CITY OF SACRAMENTO
1231 I Street, Sacramento, CA 95814

Nature of Work: REPLACE FLAT ROOF WITH TRUSS SYSTEM,INSTALL 25YR DIM COMP SHINGLE, ROOF MNT HVAC C/O, ELEC SERVICE PNL C/O - ONLY

Truss Design Submittal

Client: **Rick Ligon**
Project: **Duplex 40X46**
Address: **2202-04 20th Ave. Sacramento, Ca.**
Site Phone:
Site Contact:

Plan: Floor Systems Roof Systems
Elevation:

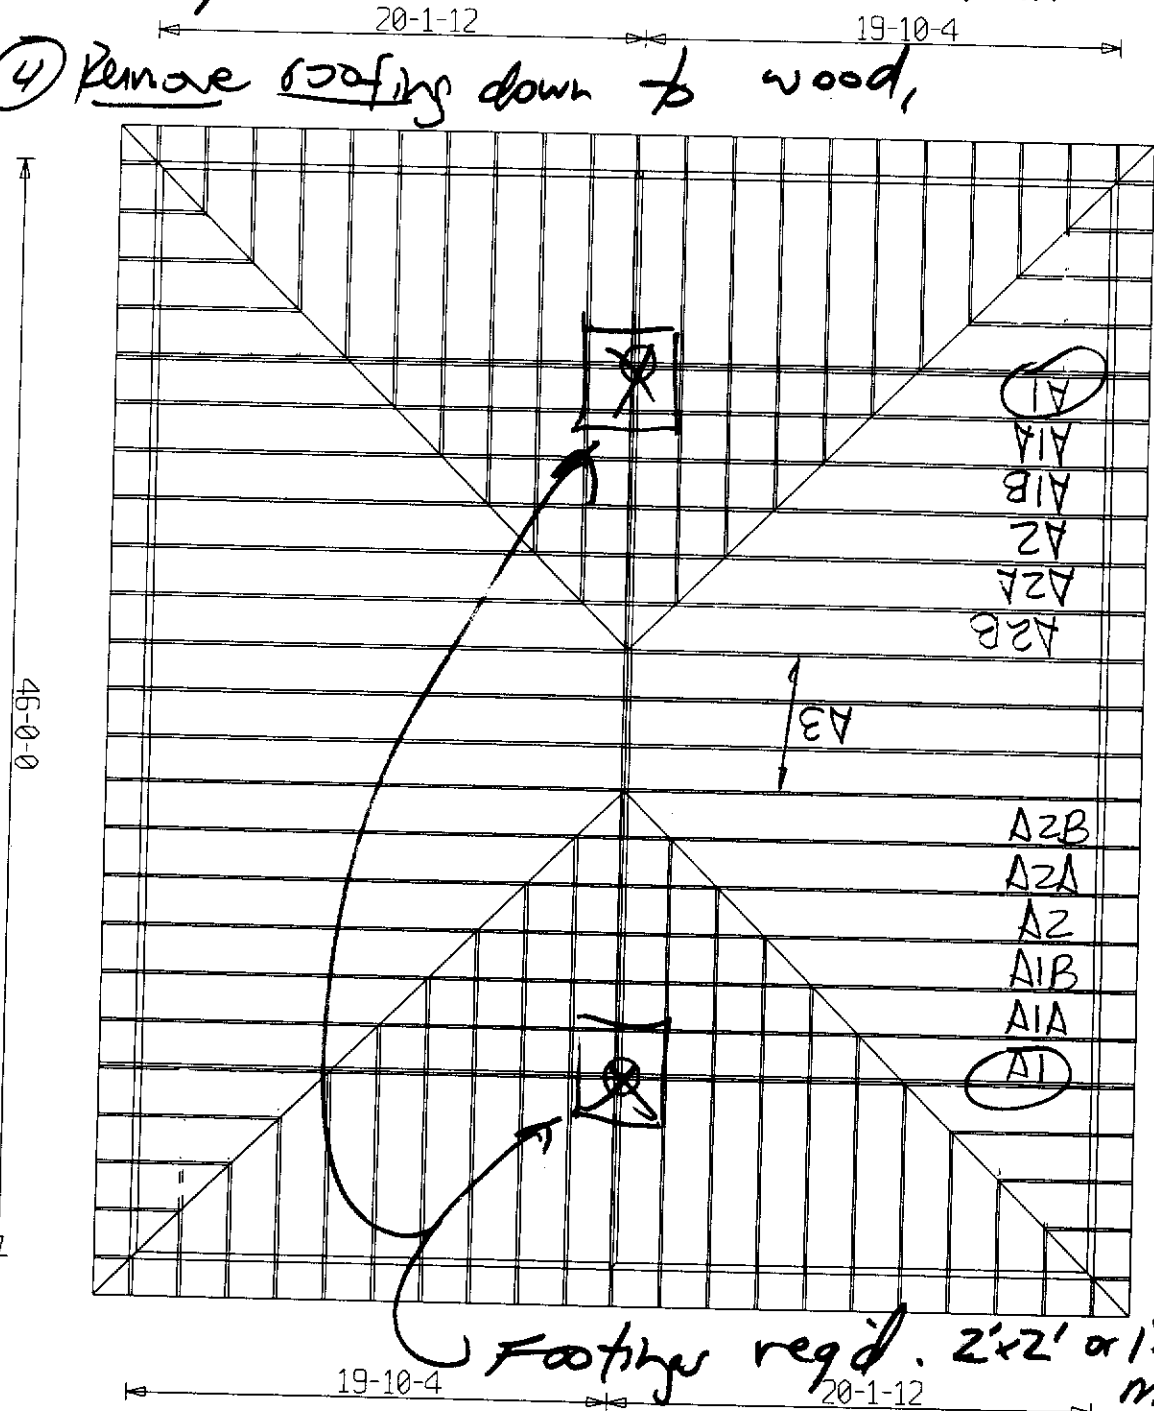
- ① Trusses checked.
- ② Verify center spread footings in field.
- ③ Verify attachments at eaves in field.
- ④ Remove roofing down to wood,

Footings req'd. 2'x2' or 1'x4' min.
